**Request for Additional Information No. 265, Supplement 1**

**U. S. EPR Standard Design Certification**

**Docket No. 52-020**

**SRP Section: 03.06.03 - Leak-Before-Break Evaluation Procedures**

**Figure 03.06.03-21-1—J-R for Aged Stainless Steel Welds**

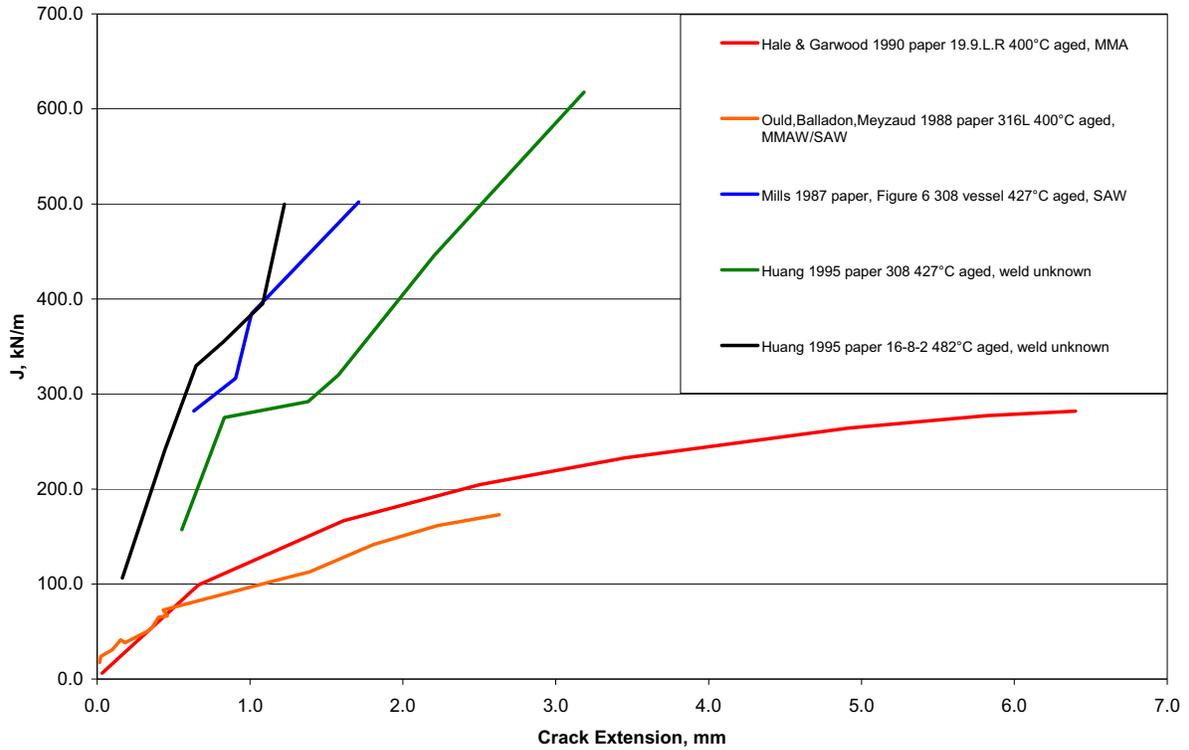
RAI Question 03.06.03-6 requested AREVA to provide details for the J-R curves used for ALL the calculations as none were provided in the original FSAR. AREVA provided the requested information during an audit conducted on June 26, 2008. The information presented to the staff during the audit indicated that for SST pipe and welds the toughness was reduced by 30% to account for thermal aging. In the formal response to RAI Question 03.06.03-6, dated 9/18/2008, AREVA indicated that the reduction in toughness was to account for heat to heat variations. The staff requests AREVA to provide the justification and the basis for the 30% reduction.

]. Because of its greater aging time and temperature, the data set from Reference 1 is a lower bound toughness data set for 316 GTAW/TIG welds. Four sets of public data (Reference 1 through Reference 4) fall below the data in Reference 1 (16-8-2 material aged for 100,000 hours at 900°F) as shown in Figure 03.06.03-21-1.

Reference 1 through Reference 4, shown in Table 03.06.03-21-1, are bounded by Huang's 16-8-2 data set, as shown in Figure 03.06.03-21-1.
